**REZONING &
SUBDIVISION STAFF REPORT**

Date: August 7, 2003

612 Shady Oak Drive Subdivision

SITE PLAN

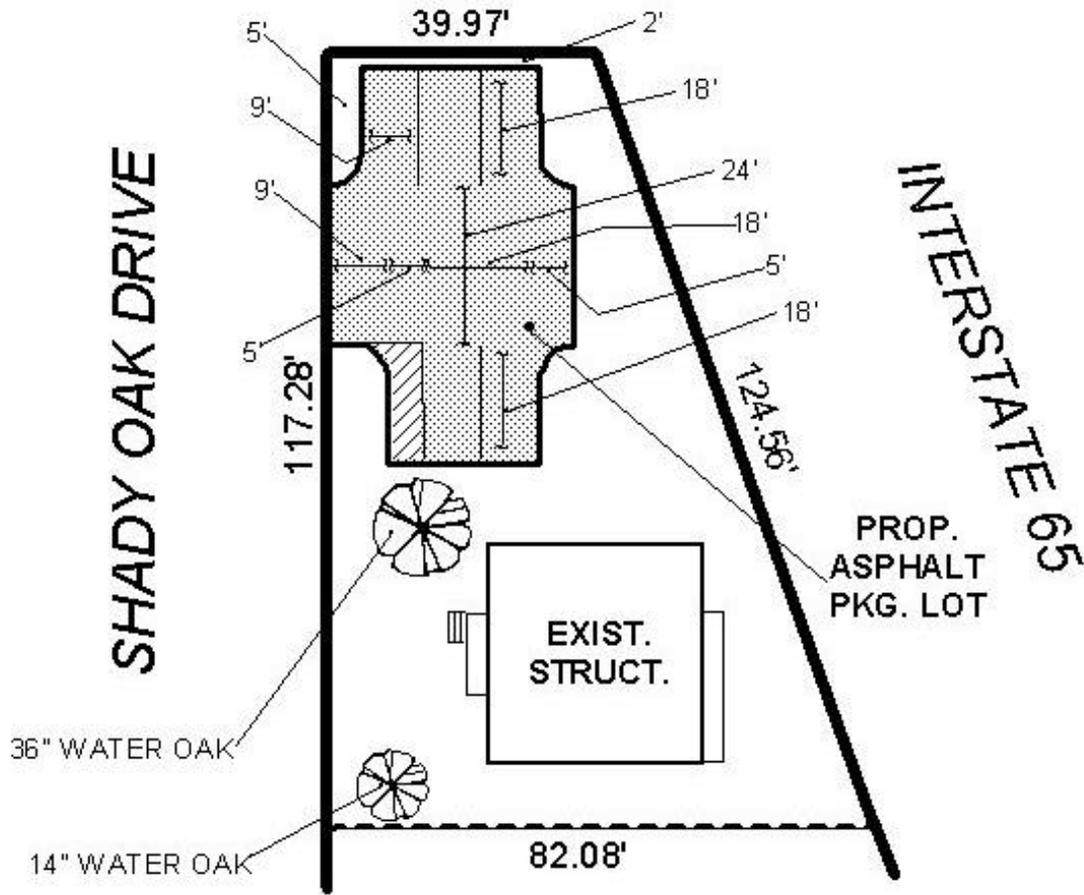
If the subdivision was approved, regardless of the rezoning, limitations on curb cuts would be appropriate since the site is bounded by streets on three sides. Additionally, as the site is considered double fronting (Shady Oak Drive and West I-65 Service Road North) the required 25’ setback should be provided from both streets.

Also, Gulfwood Drive has a substandard right-of-way of 33’. It has been the policy of the Commission to require dedication sufficient to provide 25’ from centerline when granting any type of approval on a substandard right-of-way.

Subdivision: the plat meets the minimum requirements of the Subdivision Regulations and is recommended for Tentative Approval subject to the following conditions: 1) dedication of right-of-way along Gulfwood Drive sufficient to provide 25’ from centerline; 2) placement of a note on the final plat stating that the site is limited to one curb cut, size, location and design to be approved by the Traffic Engineering Department; and 3) placement of the required 25’ setback(s) on the final plat.
